Interactive comment on “World Calibration Center for SF₆ – supporting the quality system of the global atmosphere observation” by J. Lee et al.

J. Lee et al.

Received and published: 21 January 2013

Fig. 1.

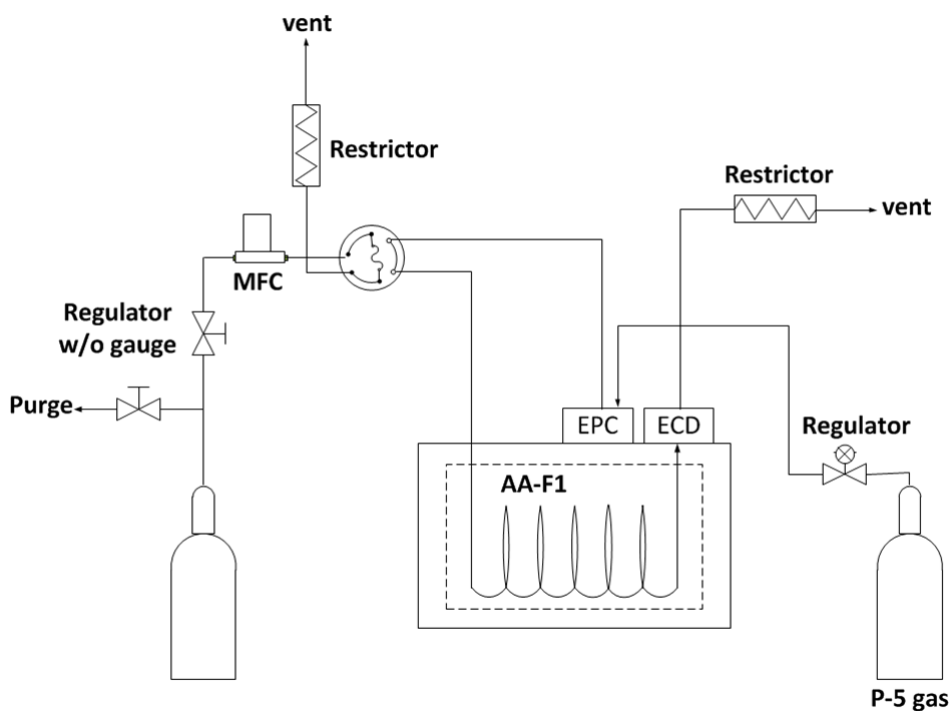
P7903, L20: Since Fig. 1 is not mentioned in the text so far, this line might be an appropriate place to refer to Fig. 1 and explain the position of the CCL according to the GAW concept.

P7916, Fig. 1: This figure is not mentioned in the text (as already noted above). Design/colour: The text in the blue box (top left) is hard to read. Mind the contrast of

colours. Replace "Roundrobin" with Round-robin". Caption: Replace "CCI" with "CCL".

=> Figure 1 will be tagged at corresponding sentence. Also the terms of reference for CCL [WMO/GAW report #172] will be briefly introduced as follow. "In GAW terminology, CCL as a central facility 1) hosts primary standard 2) serves the needs of the other quality assurance facilities and activities of GAW 3) prepare laboratory standards for calibration purpose 4) supply well-calibrated air to GAW analytic laboratories as

=> This figure will be mentioned in the text and redrawn as suggested. (Fig. S2)

Fig. S2 Traceability chain of SF6 through the CCL and GAW stations

Fig. 2.

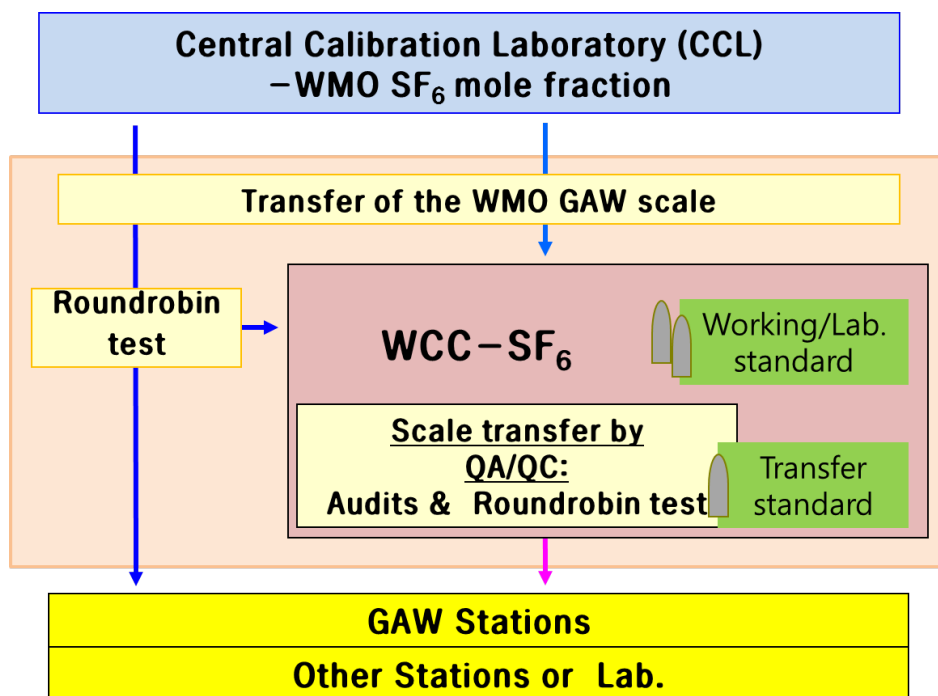
P7906, L10: “7 ml”. In Fig. 2, it is 1 and 2 ml, respectively.

P7917, Fig. 2: Font size on axes: Suggestion to enlarge as shown in Fig. 4. "Heater" obviously means "ECD". Replace "PP-Q" with "Porapak-Q". Give length of the Activated alumina-F1 column. The number for the flow is different from the one given in the main text. Use uniform unit for volume (ml or cc). Caption: Replace "...column section installed at..." with "type of column installed in the GC". Caption: Typo, replace "minites" with "minutes"

=> It is typo. It will be corrected to 1 and 2 ml.

=> Figure will be enlarged as much as possible. And caption will be corrected as suggested.
